Crestline Ford Remount Front Switch Panel Backlighting Modification

Crestline Ford Remount Ambulance

Crestline Ford Remounted Ambulances 63380 to 63389

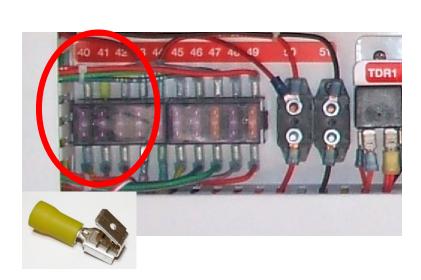
ISSUE: The Crestline added circuit for the front switch panel backlighting may be causing the Ford Smart Junction Box (SJB) to fail. If the SJB circuit fails, the backlighting for the OEM gauges will fail as well.

ACTION: Check the function of the backlighting for the OEM gauges. If the OEM backlighting has failed, diagnose the concern and repair, and then perform the following modification. Remove the power supply for the backlighting circuit and re-supply it with the clearance light circuit power.

- 1. Locate the fuses numbered 40 and 41 in the ambulance side electrical panel.
- Test these fuses to find the wires supplying power to the fuses (unplug a wire from each fuse and using a test light check for power at the wire or fuse terminal to determine the power supply wire – the clearance lights must be turned on).
- 3. Unplug the power supply side of fuse #40. Insulate the wire and leave disconnected.
- 4. Make up a jumper wire using a spade splitter terminal to plug onto the power supply wire to fuse #41 and jump to the fuse #40 input terminal. (If a splitter terminal is not available, splice the jumper wire to the power source wire for fuse #41).
- 5. Attach a label stating "BACKLIGHT MOD" to the jumper wire to mark that this modification has been performed.
 - NOTE: The switch panel backlighting will no longer have dim control.
